Public Participation Report for the Cottenham Village Design Statement Supplementary Planning Document

CVDG-REP-1004-2.0 (21st November 2007)

Cottenham Village Design Group

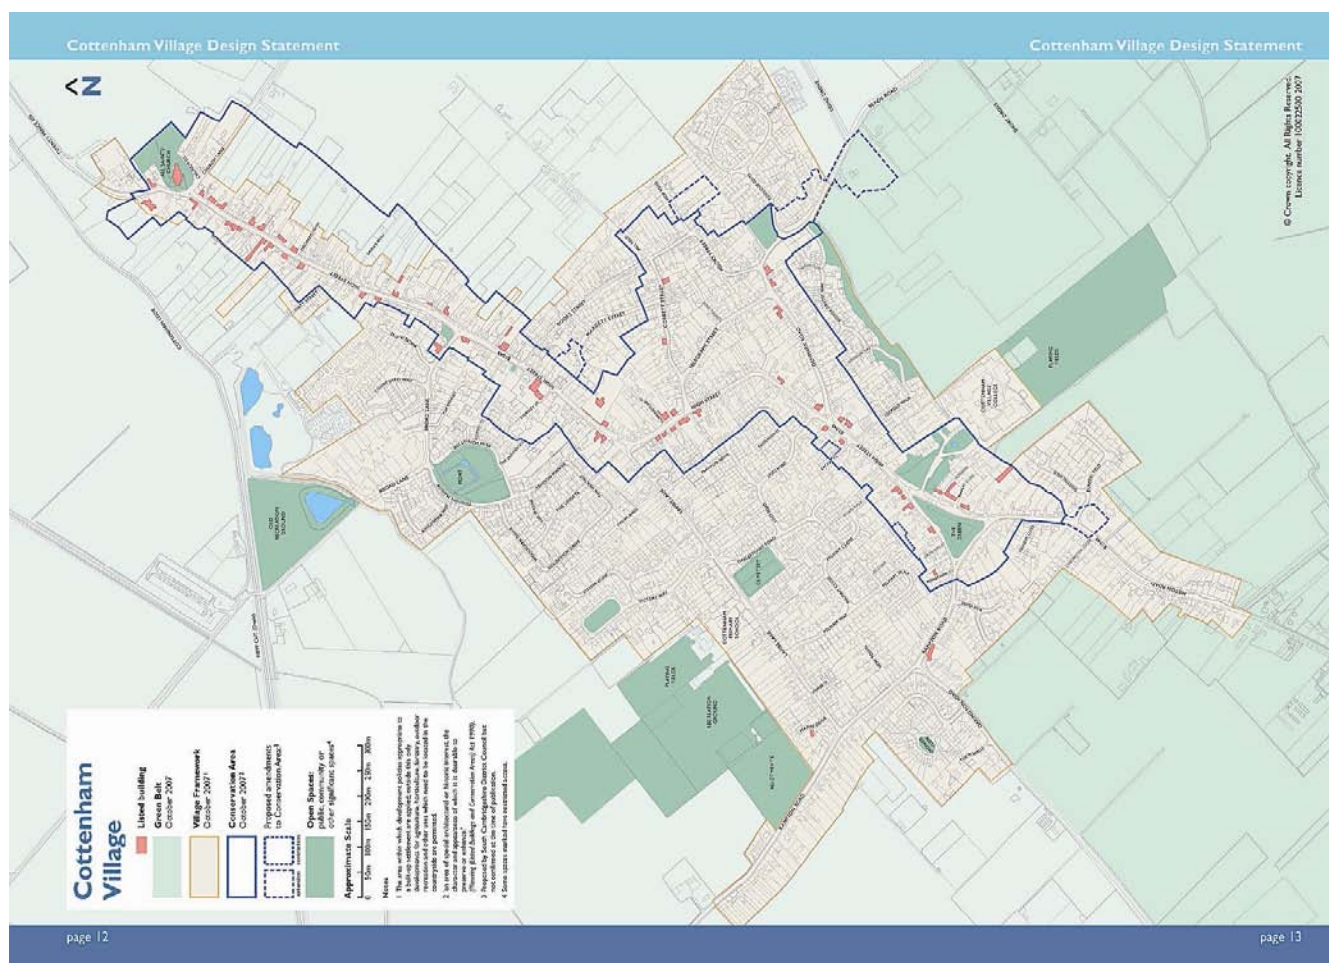
[VDSSPD], Back cover: Two new images introduced, replacing images repeated from the body of the document.
